FINAL PLAT

ALLEN ELEMENTARY SCHOOL ADDITION

RE: SUB 2001-102 -- One-Step Final Plat of Allen Elementary School Addition

STAFF REPORT
(One-Step Final Plat Approved 10/18/01)

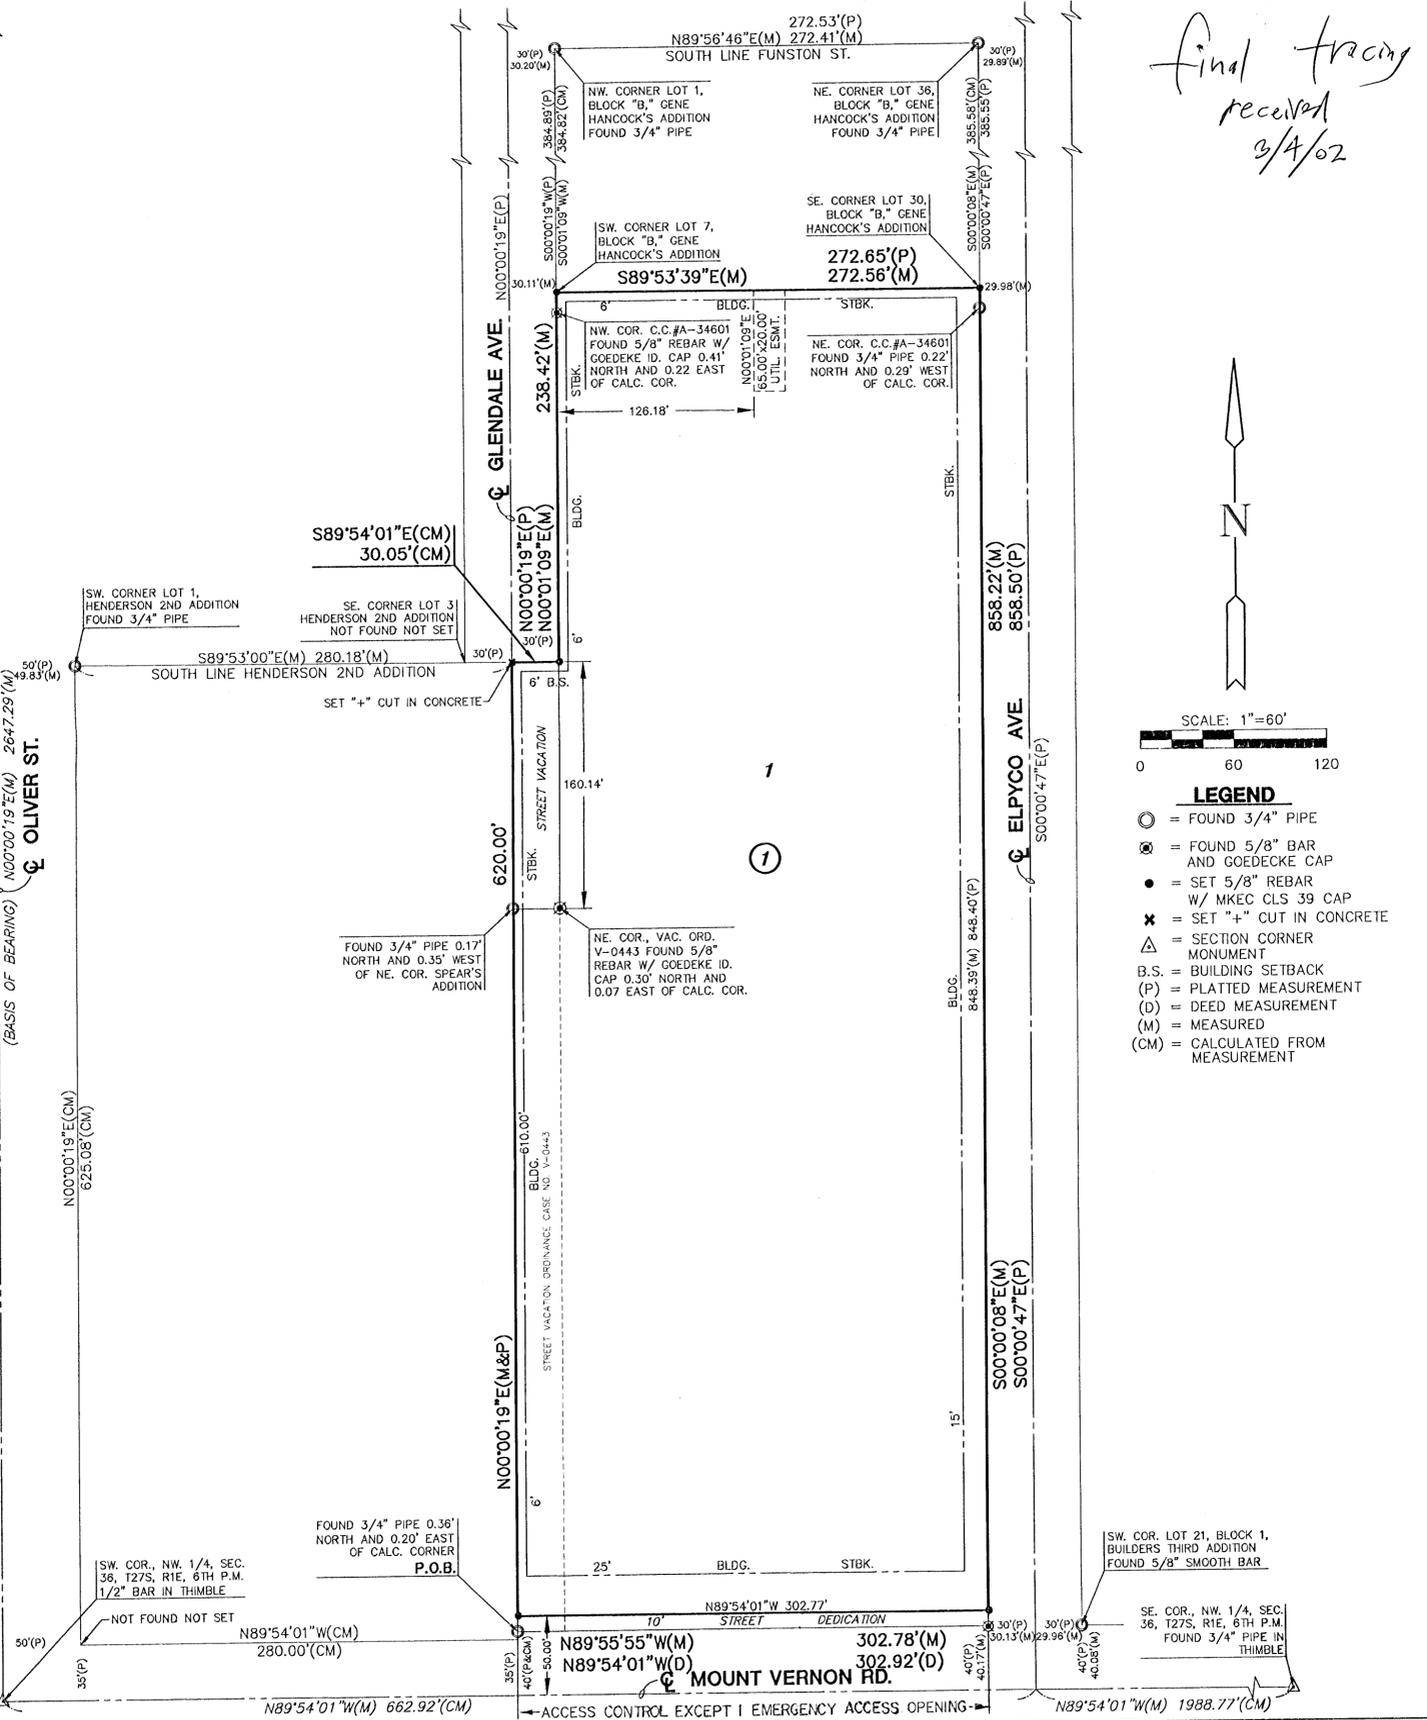
- A. Municipal services are available to serve the site. **City Engineering** needs to comment on the need for guarantees or easements. The north-south utility easement extending from the north property line needs to be reduced.

- C. **City Engineering** needs to comment on the status of the applicant's drainage plan. The drainage plan is approved.
- D. **Traffic Engineering** needs to comment on the need for additional right-of-way for Mt. Vernon which is designated as an arterial. The plat's text shall note the dedication of the streets to and for the use of the public. The applicant shall dedicate an additional 10 feet of right-of-way.

- E. **Traffic Engineering** needs to comment on the access controls. The plat proposes two access openings along Mt. Vernon and an emergency access. Traffic Engineering and MAPD have recommended complete access control along Mt Vernon Road, with the exception of an emergency access opening.

- F. A guarantee shall be submitted assuring the construction of an all-weather roadway surface for the emergency access easement. The text of the instrument shall indicate the type of driving surface to be installed and address installation and maintenance. Standard gating and signing are required per County Fire Department standards.

- H. On the final plat, the MAPC signature block needs to reference "J.D. Michaelis, Chair".
- I. Approval of this plat will require a waiver of the lot depth to width ratio of the Subdivision Regulations. The Subdivision Regulations state that the maximum depth of all residential lots shall not exceed 2.5 times the width. **A modification has been approved by the Subdivision Committee.**

- J. If determined to be part of the Glendale right-of-way, the Applicant shall contact the adjoining property owner to the west regarding the proposed vacation of right-of-way for Glendale Avenue. A vacation case shall be approved before the approval of the plat. If no off-site right-of-way for Glendale exists, the portion of Glendale as depicted within the site may be vacated through the plat. The applicant shall dedicate additional right-of-way to obtain a 30-ft wide "L"-type turnaround for Glendale Avenue.
